寄件者: AI TSANG <[redacted]>
寄件日期: 2026年10月05日星期一 14:29
收件者: Adrian Tsz Hin TAM/PLAND
主旨: TKLN 143 response TD and LD and clarification
附件: 143 response to td comment (2).pdf; 143 response to LD comment.pdf

Response to LD comment

Traffic impact proposal

1.1. The project site is submitted S16 Planning Application for proposed Temporary Eating Place and Green Fuel Station with Ancillary Facilities for a Period of 3 Years.

Total Site Area: 980㎡(About)

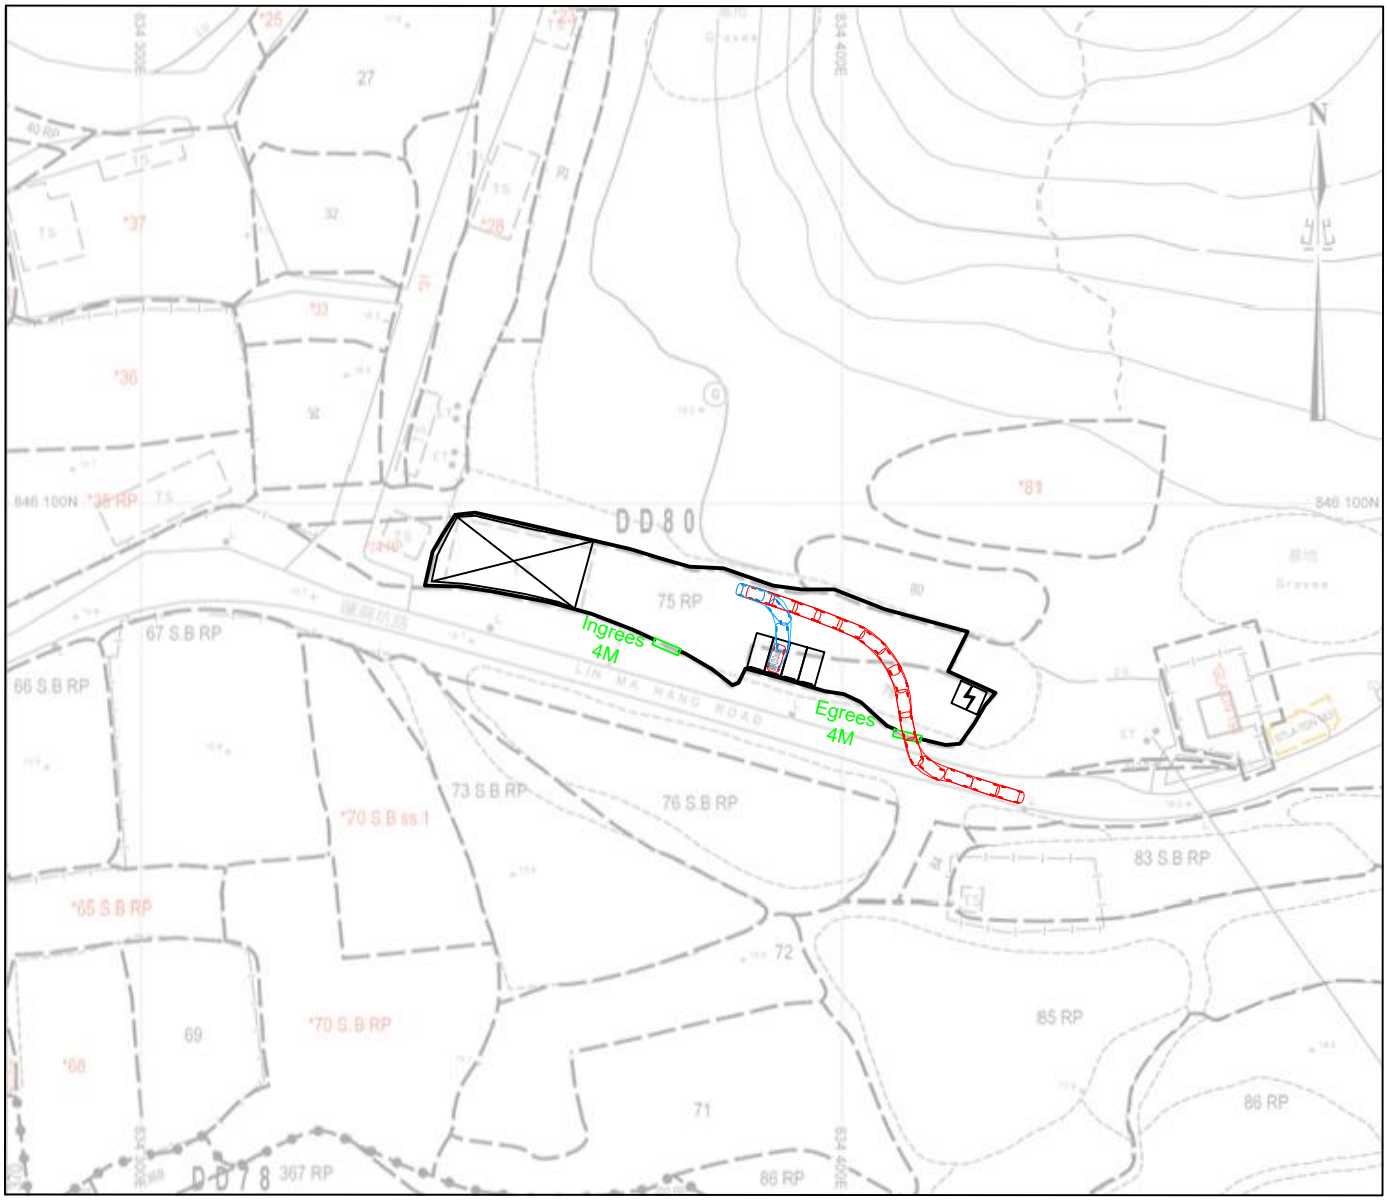
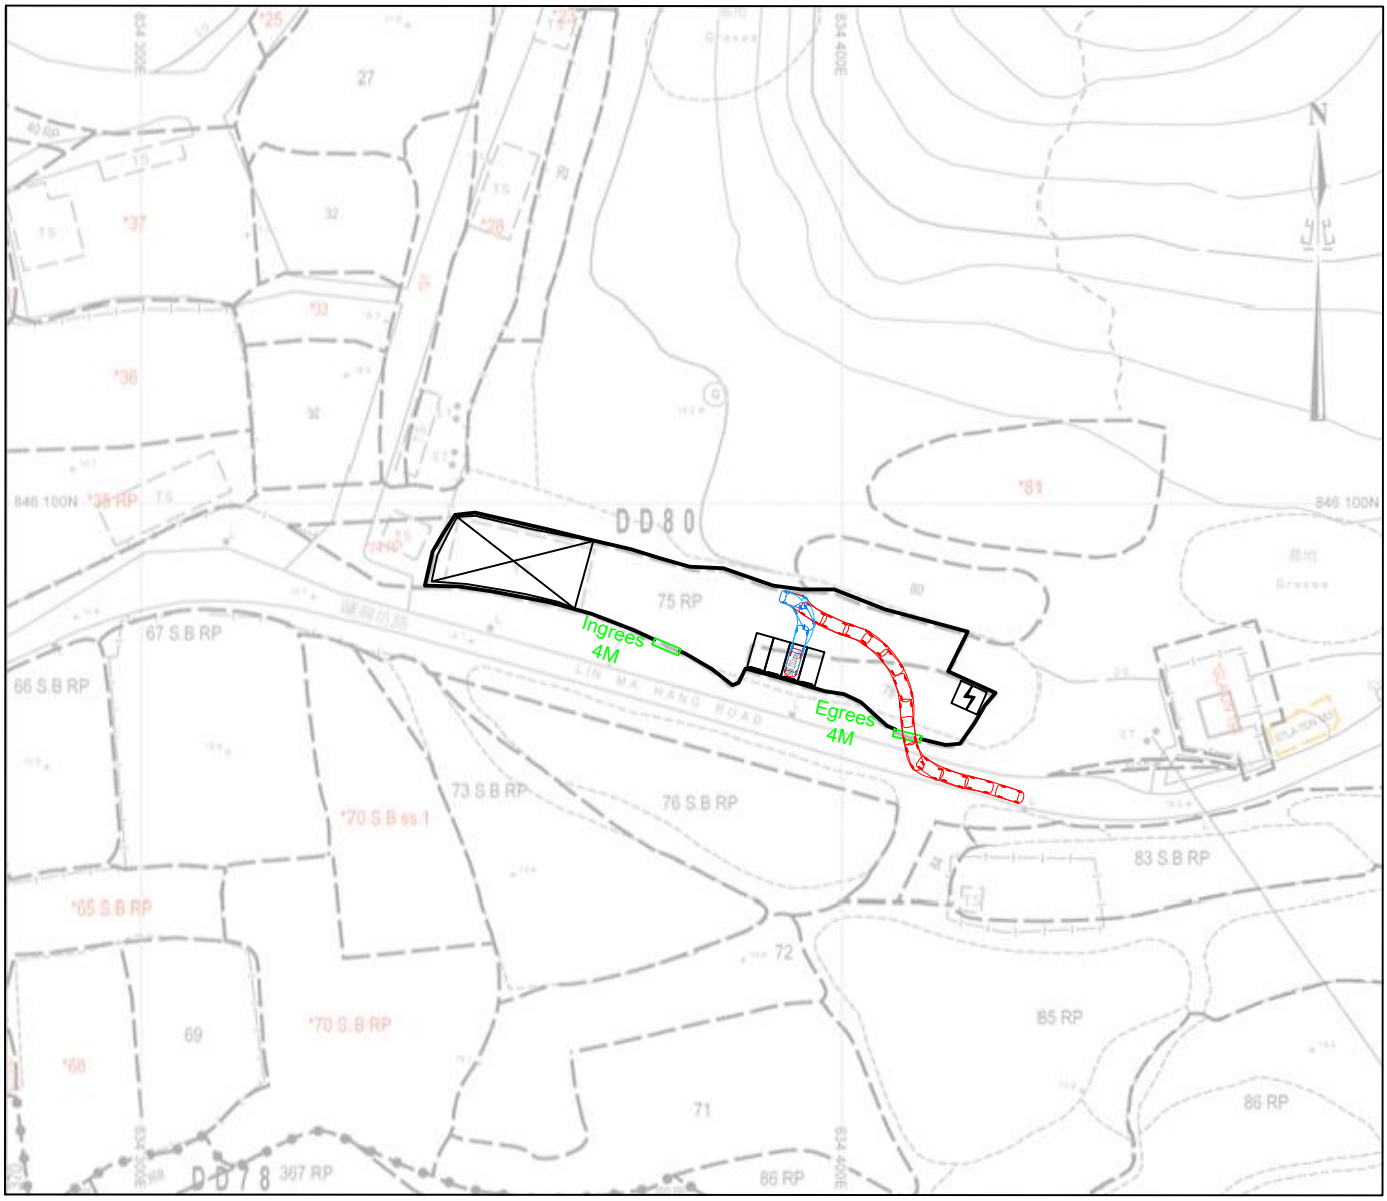
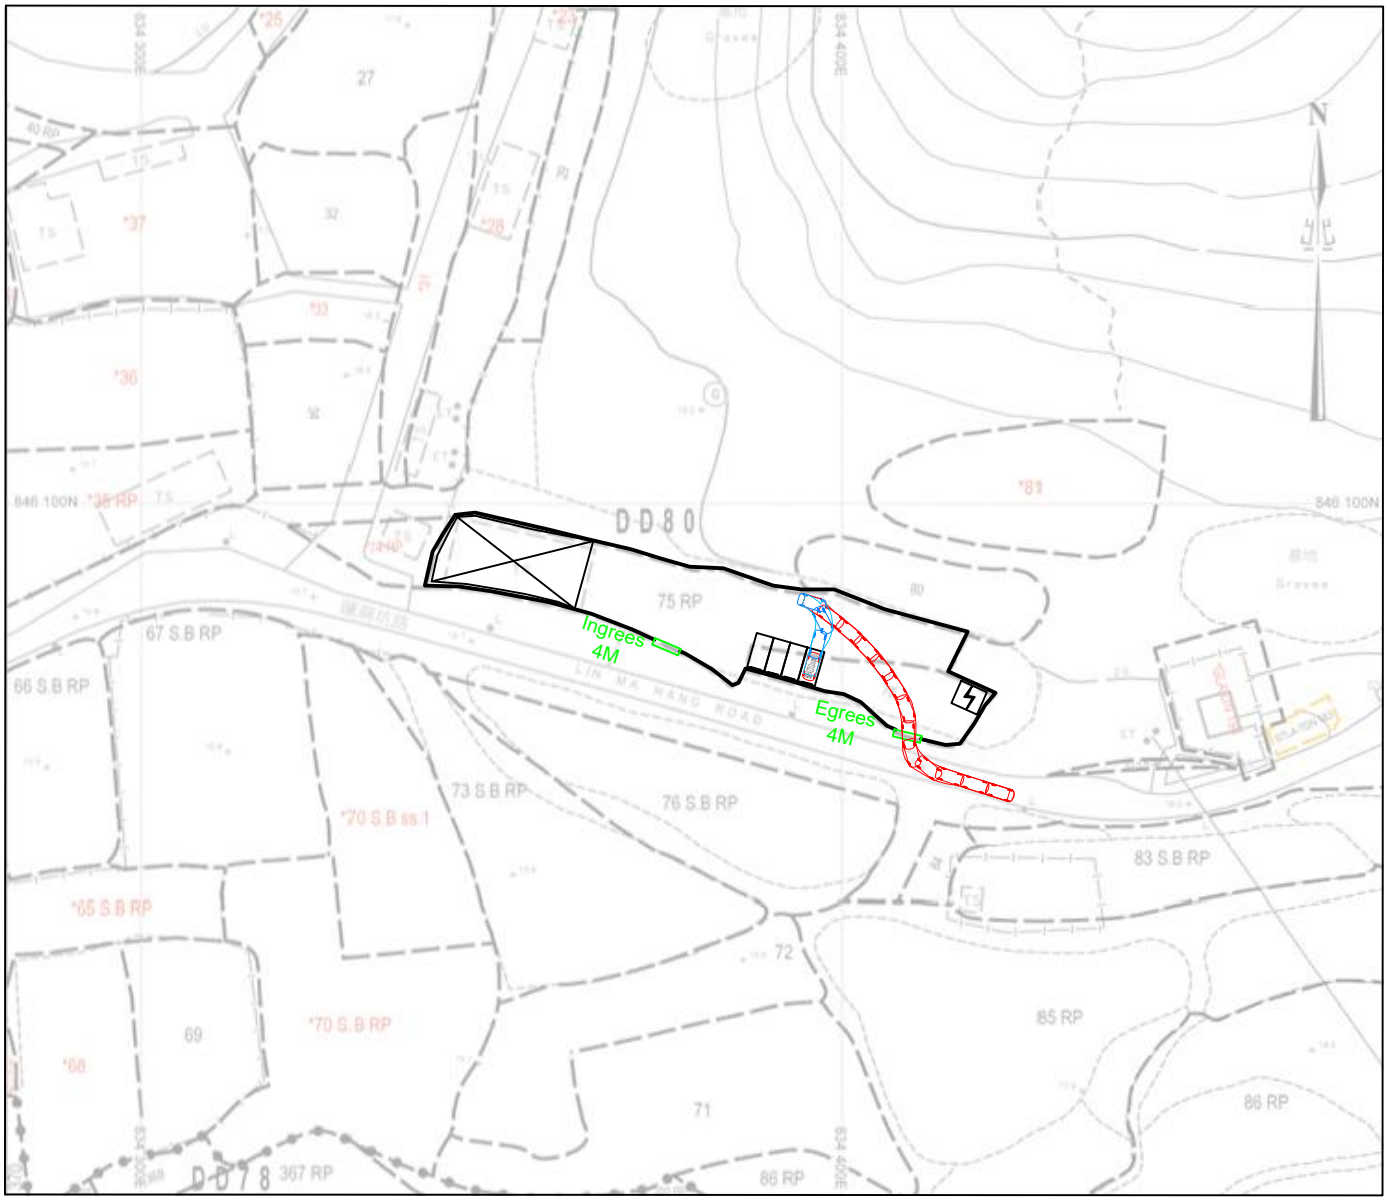
Comment 3
the applicant shall demonstrate the satisfactory maneuvering of the vehicles entering and exiting the application site, maneuvering within the application site and into/out of the parking preferably using the swept path analysis; and
Response
Please refer to swept path plan

1.4. Swept Path Analysis has been conducted for the access points and passages. The site access points and parking arrangements are sufficient for safe maneuvering and operation.
